UNITED STATES
NUCLEAR REGULATORY COMMISSION
WASHINGTON, D.C. 20555-0001

SUBJECT: SUMMARY OF AUGUST 16, 2012, MEETING WITH DUKE ENERGY CAROLINAS, LLC, TO DISCUSS THE INSTALLATION OF MAIN STEAM ISOLATION VALVES AT OCONEE NUCLEAR STATION, UNITS 1, 2, AND 3 (ONS 1/2/3)(TAC NOS. ME8504, ME8505, AND ME8506)

Main Steam Isolation Valve License Amendment Request

Oconee Nuclear Station
August 16, 2012

Duke Energy Current TDEFWP Operation (AFIS)

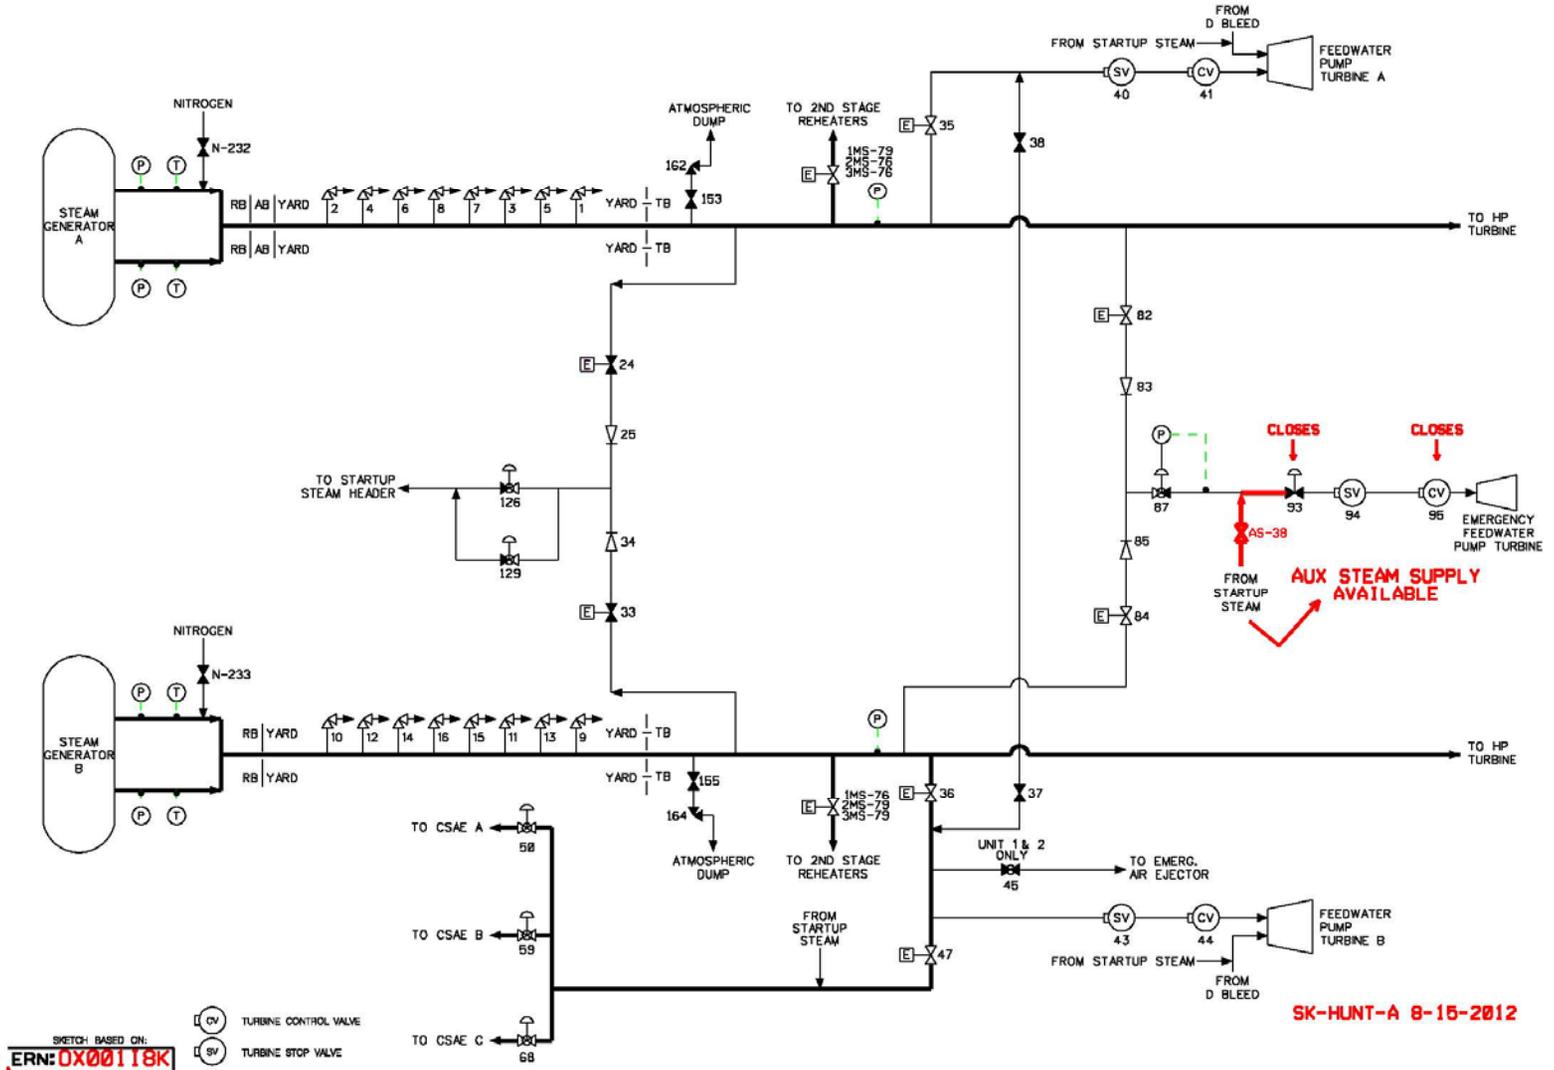
- ❖ The Automatic Feedwater Isolation System (AFIS) currently isolates the steam supply to the TDEFWP on low MS header pressure to mitigate RCS overcooling
- ❖ For an MSLB in the Turbine Building, EFW may be available from the affected unit or via the cross tie from another unit
- ❖ For an MSLB in the Auxiliary Building, EFW will be available
- ❖ For inadvertent closure of an MSIV, the remaining MS header continues to provide steam to the TDEFWP
- ❖ Based on the above, installation of the MSIVs does not adversely affect mitigation capability of the EFW System

Post-MSIV Implementation TDEFWP Operation (AFIS)

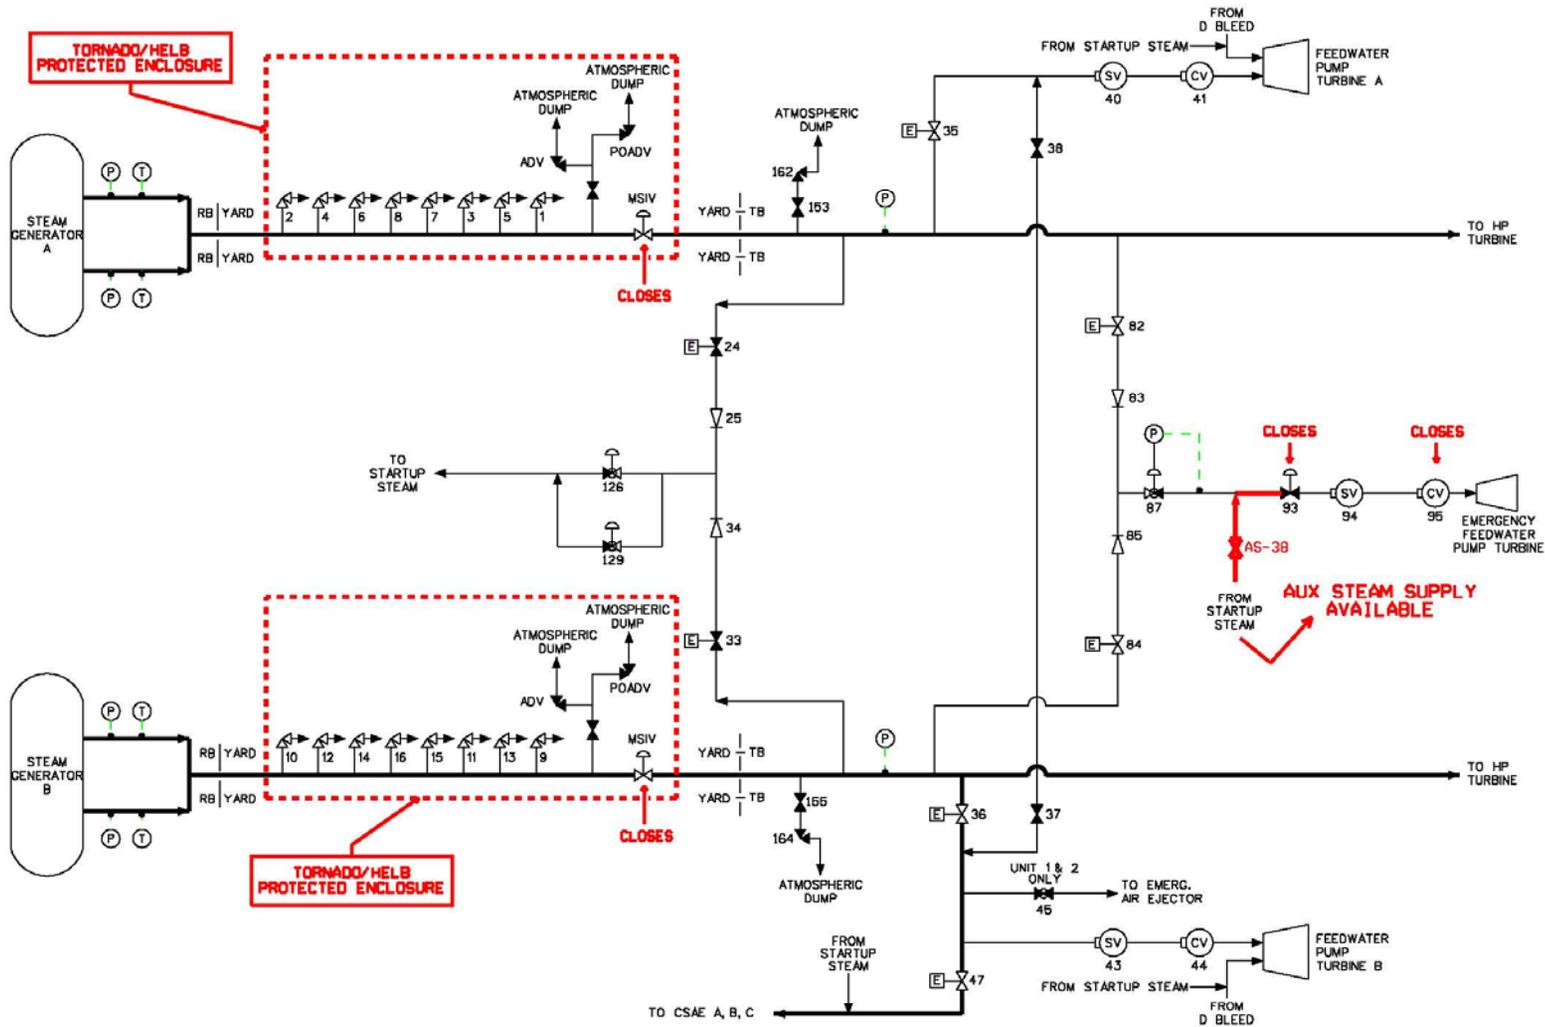
The licensee stated that the steam supply lines from the main steam header to the TDEFWP would not be moved, and would now be located downstream of the MSIVs. The licensee stated that they believed this was acceptable, as the TDEFWP will also be automatically supplied from the auxiliary steam header if the auxiliary steam pressure is greater than the supply from the main steam header. The auxiliary steam header can be supplied from any of the three units, although it is normally supplied from only one selected unit at any given time. The licensee also stated that the EFW systems can be cross-tied among units, allowing EFW to the steam generators to be supplied from a different unit, although operators have to perform the cross-tie in the turbine building. The licensee further stated that the MSIVs would be designed to remain open for a loss of all alternating current (AC) power, as long as they did not depressurize to the low pressure setpoint. The MSIVs would have an automatic closure signal from the Automatic Feedwater Isolation System on low steam pressure sensed upstream of the MSIVs. The NRC staff continued to state some concerns with having the TDEFWP steam supply downstream of the MSIVs. The licensee is aware of the NRC staff's concerns. One possible method would be to submit the design for prior NRC approval, so the licensee could be assured of regulatory approval before starting construction. The licensee stated that there would be no partial stroke test during power operations. The NRC staff agrees that such a test is not required by standard technical specifications, NUREG-1430.
